UNITED STATES OF AMERICA  
NUCLEAR REGULATORY COMMISSION

In the Matter of	)	
	)	Docket Nos. 50-445 and
TEXAS UTILITIES ELECTRIC	)	50-446
COMPANY, ET AL.	)	
	)	(Application for
(Comanche Peak Steam Electric	)	Operating Licenses)
Station, Units 1 and 2)	)

AFFIDAVIT OF ROBERT C. IOTTI AND  
JOHN C. FINNERAN, JR. REGARDING  
BOARD REQUEST FOR INFORMATION  
CONCERNING A36 AND A307 STEEL

Figure 1

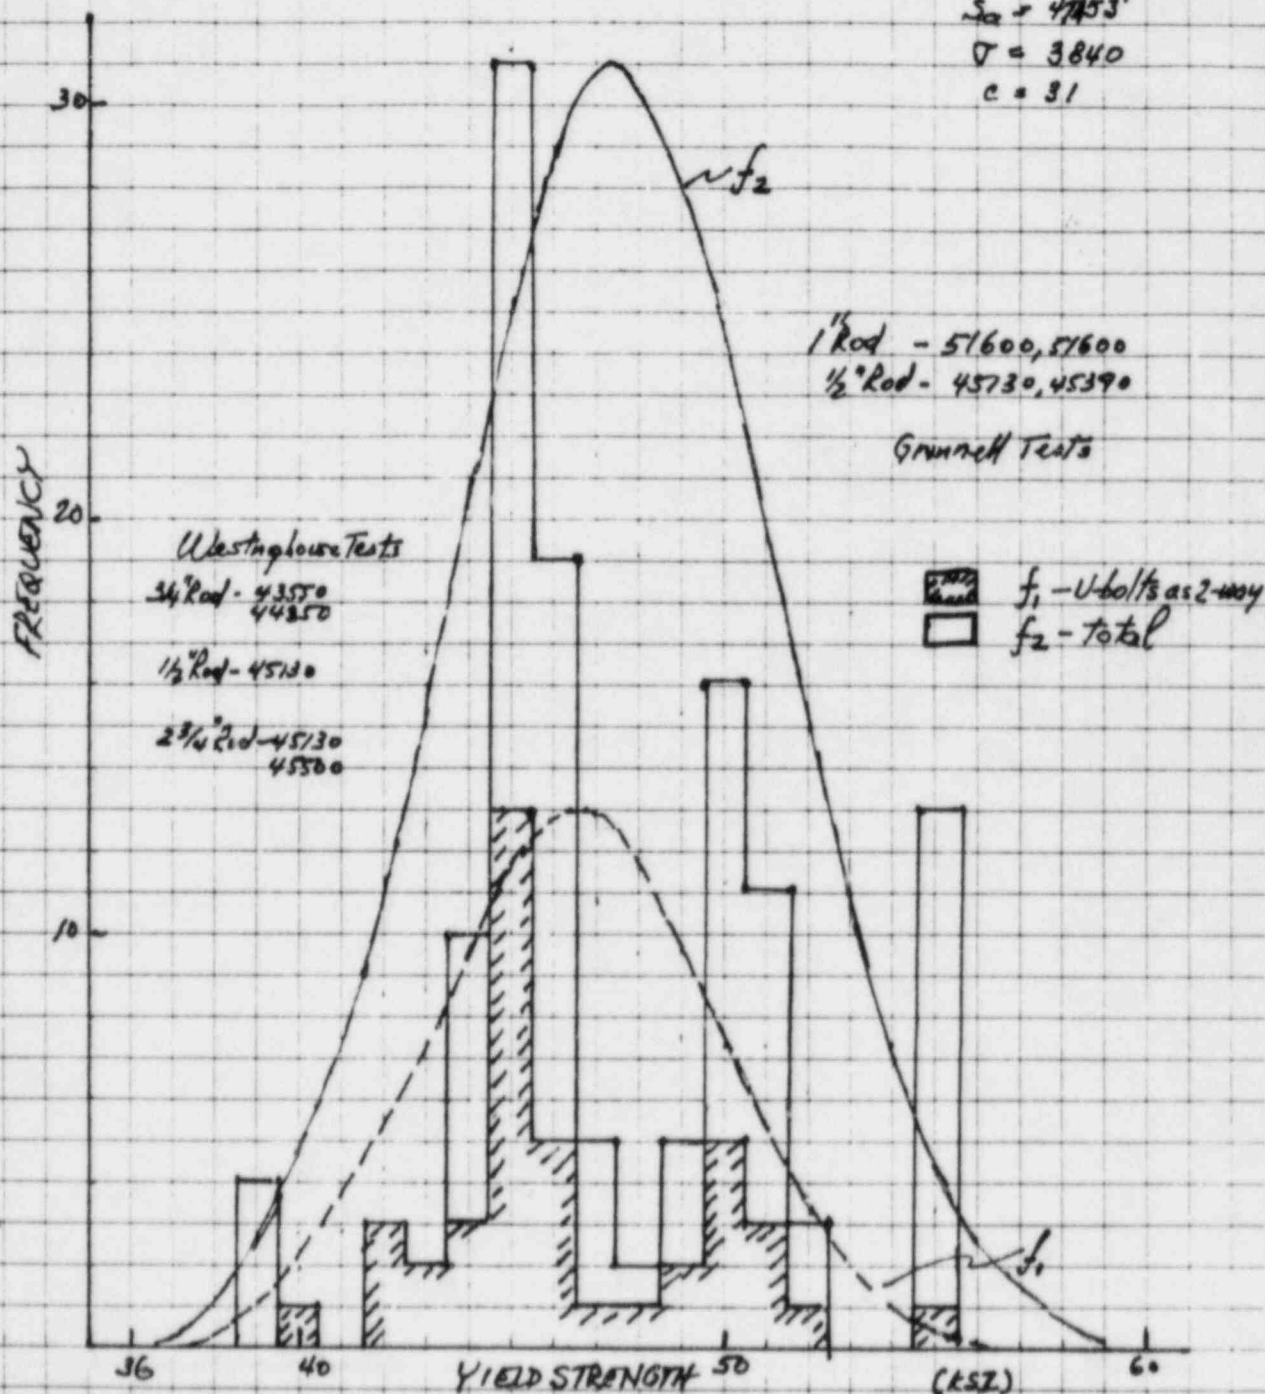
- Q. Are the properties of the materials employed in these tests representative of the steels employed in the plant?
- A. Yes. Figure 1 (attached) shows the distribution curve of the yield strengths of the SA36 steels employed in the plant. The distribution curve for ultimate strength is similar, and is shown in Figure 2. Also shown on these figures are the yield strengths and ultimate strengths of the actual steels employed in the test specimens.
